Re: **VAC2001-00017**- Request to vacate part of drainage easement generally located Legion and Bella Road (6130 North Legion).

STAFF REPORT

CASE NUMBER: VAC2001-00017: Request to vacate a portion of a 20-ft drainage easement.

VICINITY MAP:

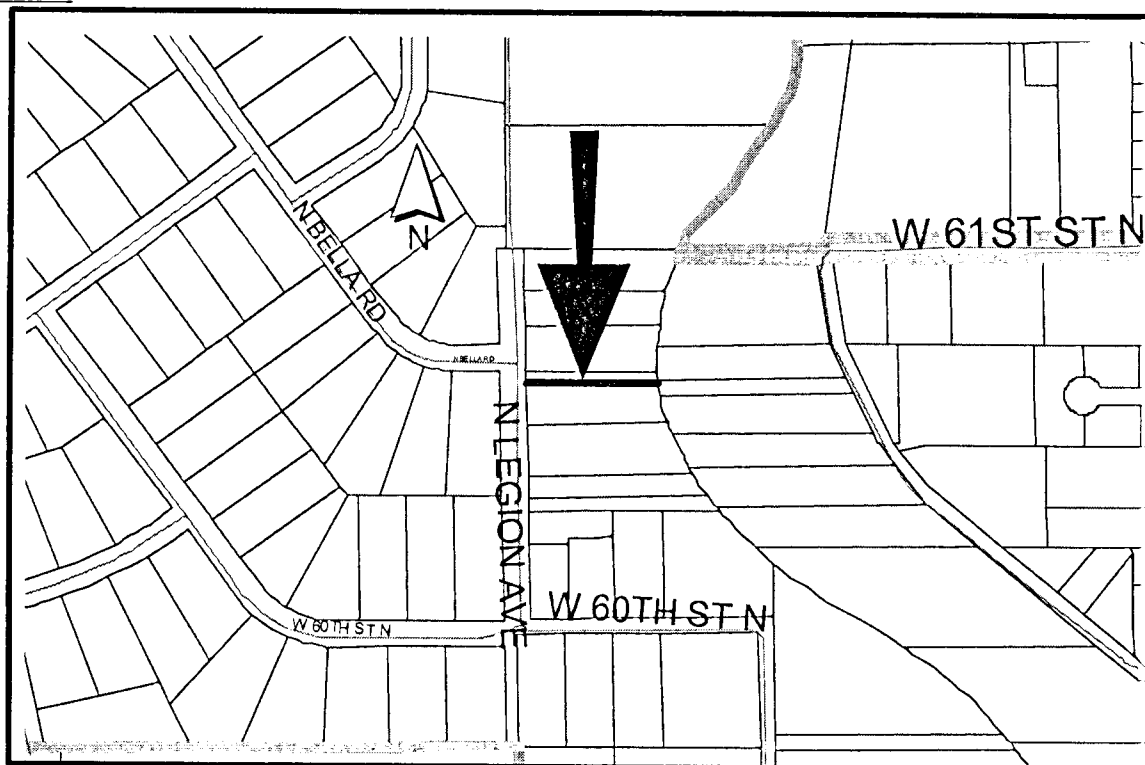
The applicant is requesting consideration to vacate a portion of a 20-ft drainage easement. The easement was not dedicated or shown on the plat, but was recorded on a separate instrument. Approximately 3-ft – 3.9-ft of the north end of the applicant's house currently encroaches on the easement. The applicant is requesting that the south 6-ft (running the length of the easement) of the easement be vacated. The 6-ft the applicant is requesting would leave the house clear of the easement by 1-ft – 1.9 ft. There is a 4-ft drainpipe in the easement. The 6-ft the applicant is requesting would place the drainpipe approximately 2-ft from the south edge of the easement. The easement and the drain pipe end at the Little Arkansas River.

- 1. The applicant shall dedicate the south 6-ft of the North 11-ft of Lot 141, Van View Add., Sedgwick County, Kansas as part of a 20-ft drainage easement

- 2. The applicant shall verify, via a survey, the location of the 4-ft drainage pipe in the 20-ft easement.
 - 3. Any relocation or reconstruction of utilities made necessary by this vacation shall be the responsibility of the applicant.
